Site Plan Review Committee (SPRC)
Staff Report for
3033 Wilson Boulevard (Clarendon Square)
SPLN24-00003

3033 Wilson Blvd (SPLN24-00003)
Clarendon Square
(RPC #15-067-002, -003, -005, -006, -007, -033, -036)

SUMMARY:**January 2025: Changes since initial filing and last staff report:**

Figure 10. Overall Level 1 Floor Plan

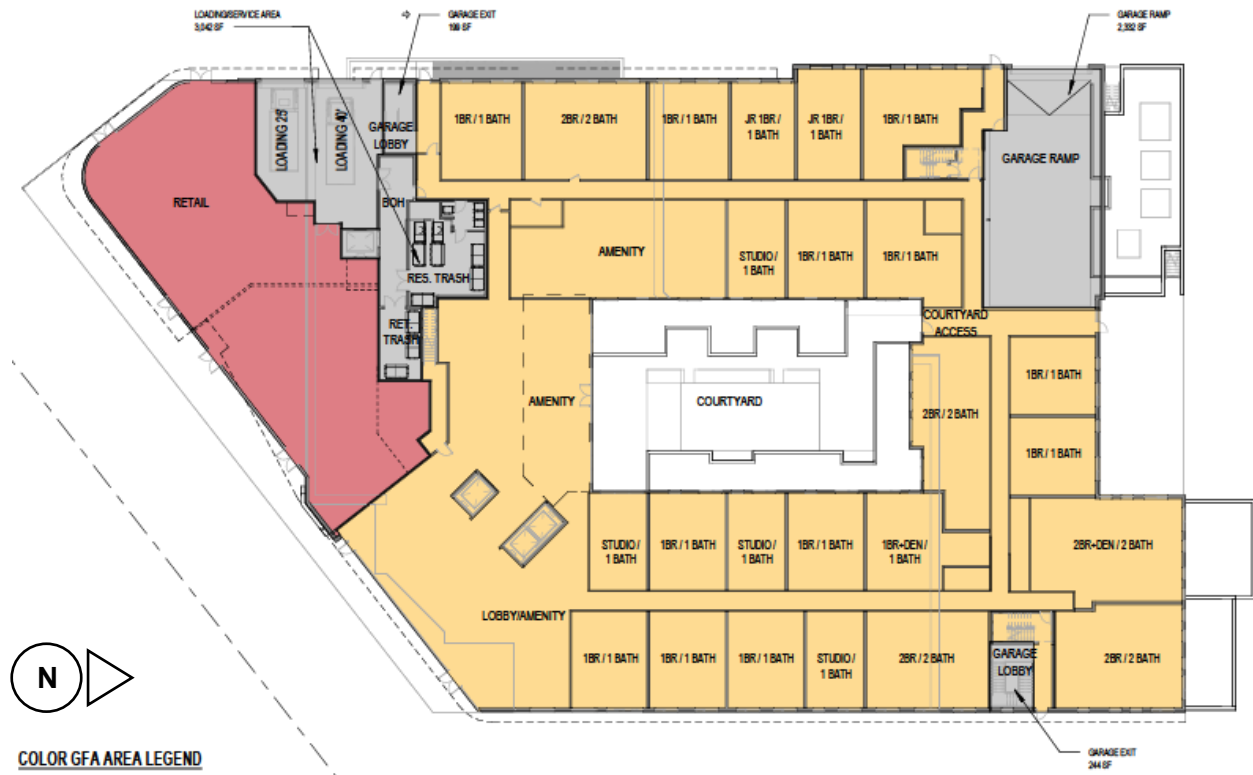
Site Design & Layout: The site consists of one multifamily building of eight (8) stories in height. On the ground level, retail spaces face Wilson Boulevard and the public plaza. The lobby faces the intersection of Wilson and Garfield Street. Individual dwelling units face both Garfield and Highland Streets but have no direct access to the street. The entrance to the underground parking garage is at the rear of the property on Highland Street. The two (2) loading spaces are also on Highland Street, but closer to the intersection of Wilson and Highland. **Since the initial filing, the applicant has moved the podium of the building back a few feet in order to accommodate the protected Wilson Boulevard bike lane and to provide as much total streetscape width as possible (give the placement of the existing garage columns that the**

applicant will reuse). This results in a 20' total streetscape width, as recommended in the Sector Plan, in front of the retail on Wilson Boulevard, and a streetscape of 17' elsewhere on Wilson (with a 14' pinch point where an existing column cannot be moved). At all times the developer proposes a consistent eight (8) foot clear pedestrian path and a six (6) foot planting strip (both the clear sidewalk path and the planting strip width meet the sector plan recommendations and Zoning Ordinance requirements). The variation on total streetscape width is taken out of the private shy zone area, not the public clear sidewalk and public planting strip.

Figure 18 - Proposed Wilson Boulevard Cross Section

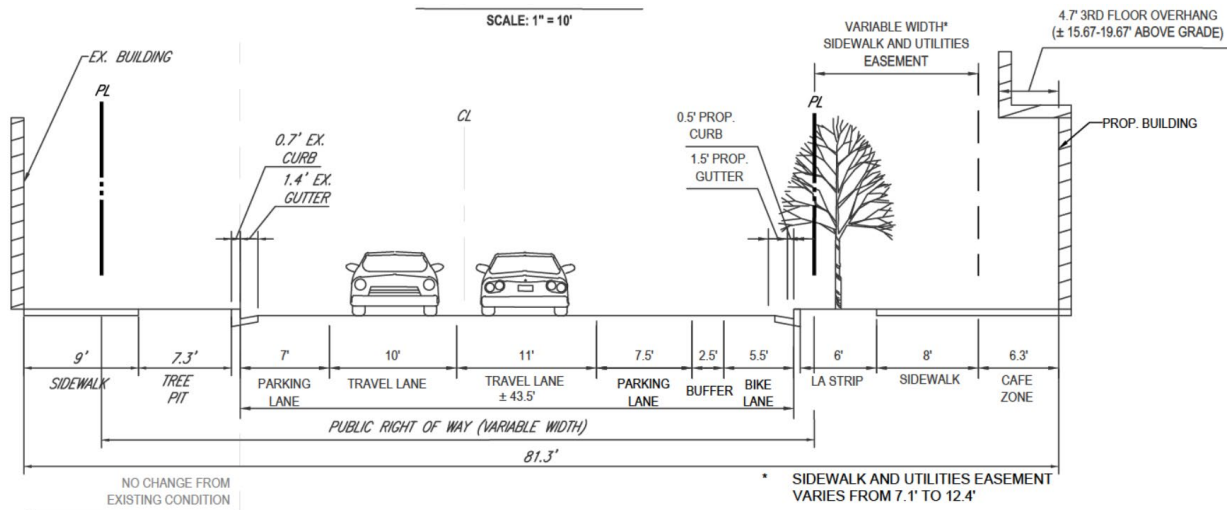
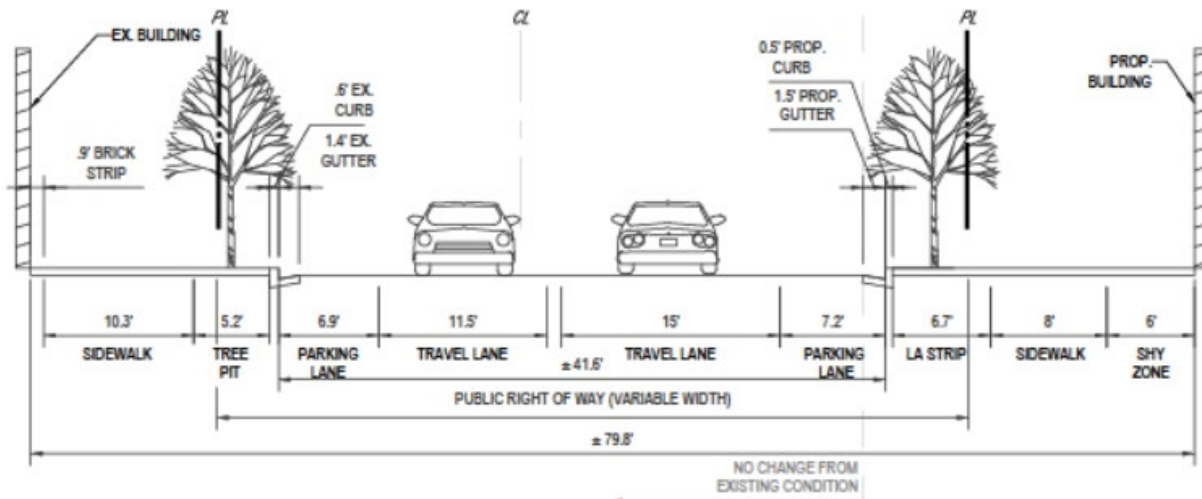
Total streetscape width on Wilson Boulevard: The ACZO requires a total streetscape width (which is the sum of the clear sidewalk + shy/café zone + planting strip) of 20 feet. The developer proposes 18 feet but will maintain the recommended clear sidewalk width of eight (8) feet. The developer states this is because of the placement of the foundation columns and is a result of their desire to reuse that parking garage. Staff is studying this request.

- Protected bike lane added to Wilson Boulevard;
- Building placement adjusted along Wilson Boulevard to provide up to 20-foot total streetscape.
